**ENGINEERING EVALUATION OF
CITY OF SPRINGFIELD
FLOOD HAZARD REDUCTION PROJECT BETWEEN
HOLLAND AVENUE AND CAMPBELL AVENUE**

**Prepared for:
City of Springfield Missouri
Department of Public Works**

**Prepared by:
Wright Water Engineers, Inc. (WWE)
Denver, Colorado**

Figure 2
Fassnacht Creek HEC-RAS Cross-section
Upstream of Campbell Street Bridge

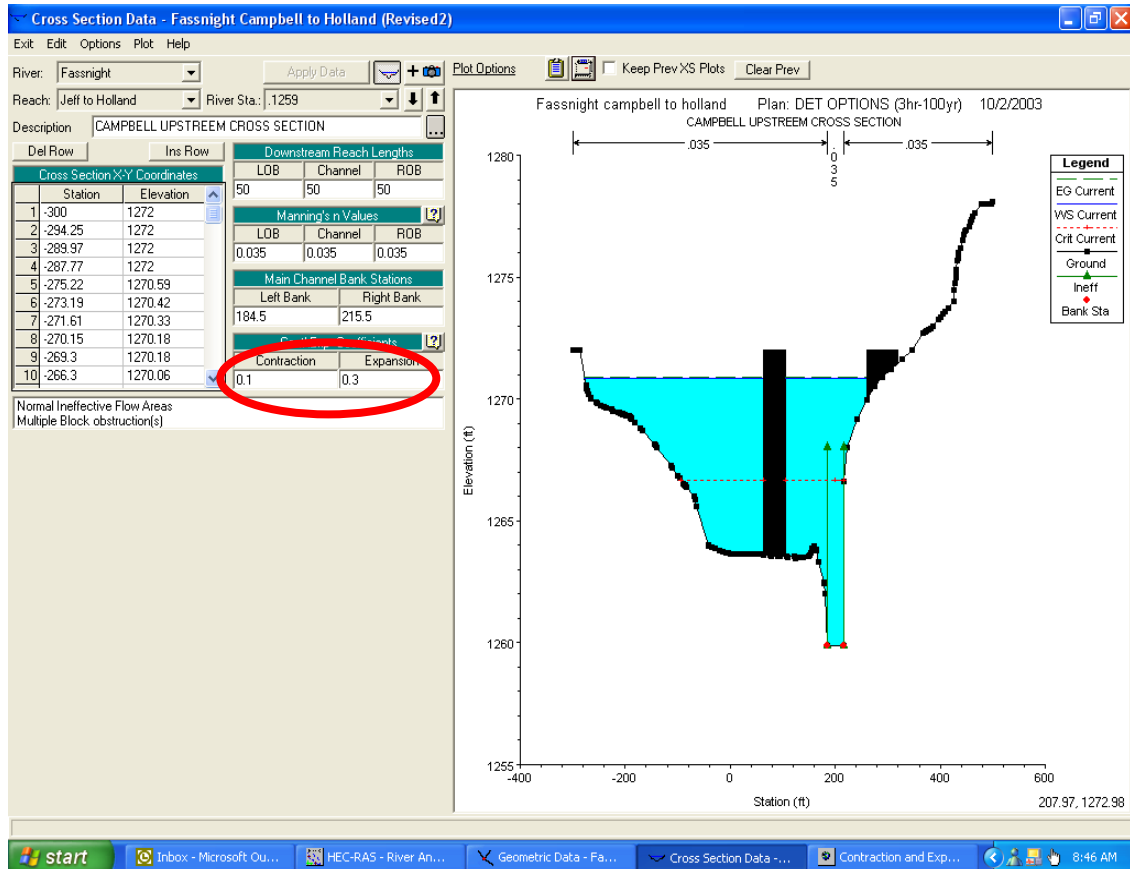
Expansion and contraction coefficients—Figure 2, shows that the expansion and contraction coefficients are, respectively, 0.3 and 0.1. Typical expansion and contraction coefficients upstream and downstream of bridges are usually closer to 0.5 and 0.3. An example model profile is included in Figure 2. For abrupt transitions, more typical coefficients would be 0.8 and 0.6. This observation is characteristic of cross-sections immediately upstream and downstream

of bridges in all of the Fassnacht Creek model runs. This modification should not significantly change the model results, but could cause a slight increase in water surface elevations upstream of the bridges.

Figure 3
Fassnight Creek HEC-RAS Cross-section
In Reach Between Bennett Street and Campbell

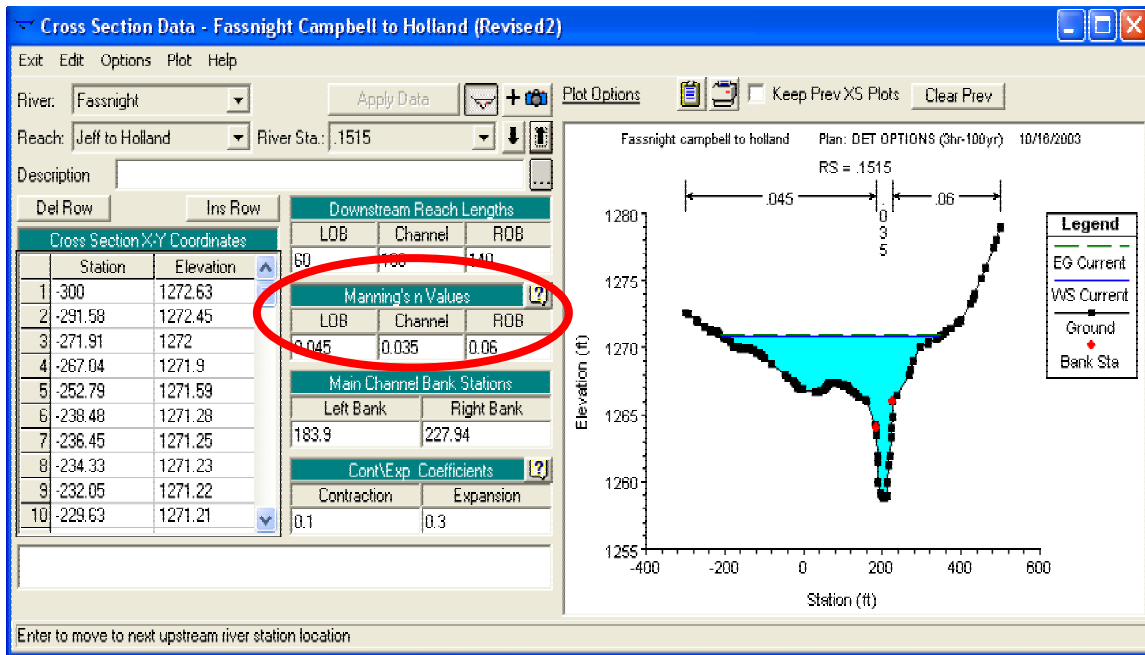
Manning's n values appear to be low in some reaches, particularly for the reach from Bennett Street to Campbell Avenue. For example, the Manning's n for this reach ranges between 0.02 and 0.06, which is low based on field inspection and photographs. An example model cross-section from this reach is provided in Figure 3. All model results and comparisons are shown in the tables provided by the City of Springfield with the modeling package and in the Fassnacht manning summary.xls spreadsheet, provided in Appendix A.

The implications of under-estimating friction factors are significant, because the City calibrated their HEC-RAS model to measured flood depths in the July 12, 2000 flood, and described this as a 100-year flood. Had higher friction factors been utilized, which would have been justified a selected cross section, the subject flood would have been characterized as less severe than the 100-year flood. This subject is discussed in Section 5.4.2.

Figure 4
100-year, 3-hr Encroachment Water Surface Profile

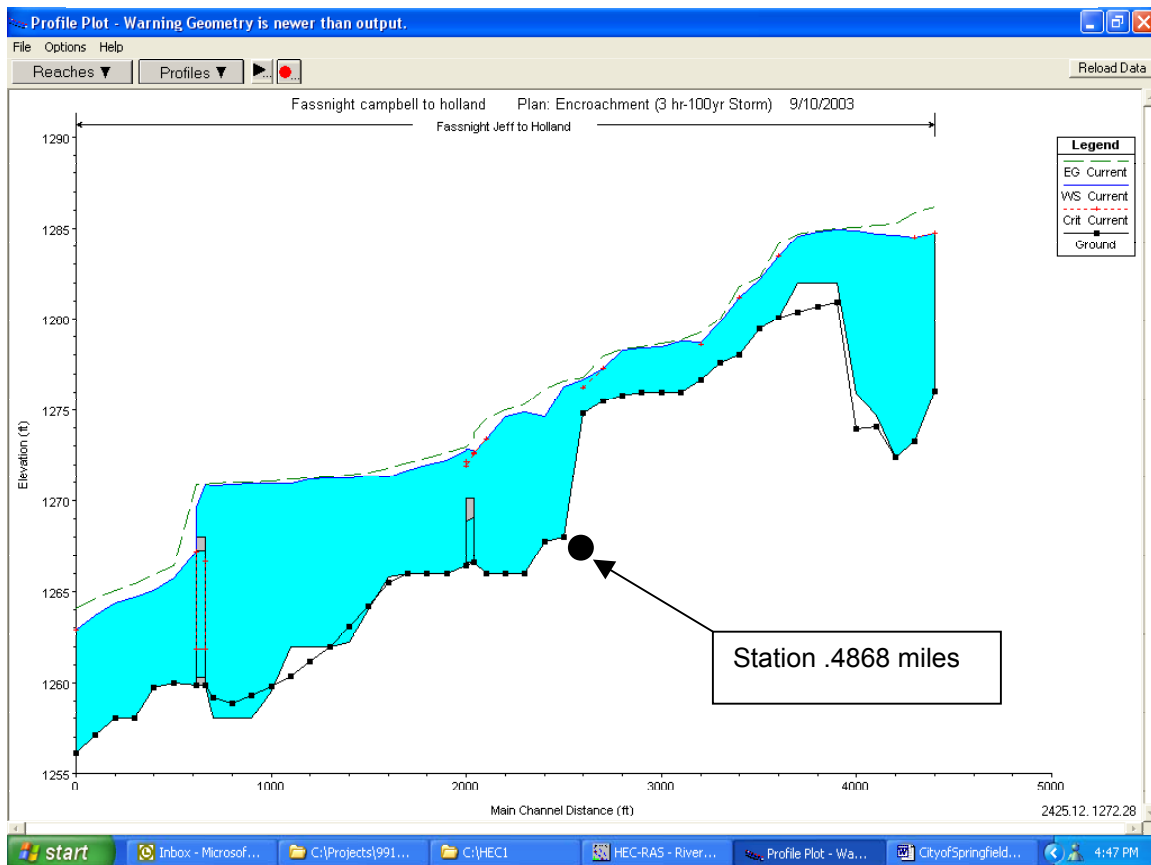
The hydraulic profile for the Encroachment (3-hr, 100-year) storm appears to demonstrate that one cross-section station is missing. WWE has indicated the apparent location in Figure 4. We recommend that this cross-section be added for the sake of consistency between models. The cross-section that appears to be missing is located at river station 0.4868, at the Jefferson Avenue culvert outlet. All other hydraulic profiles appear to be reasonable.
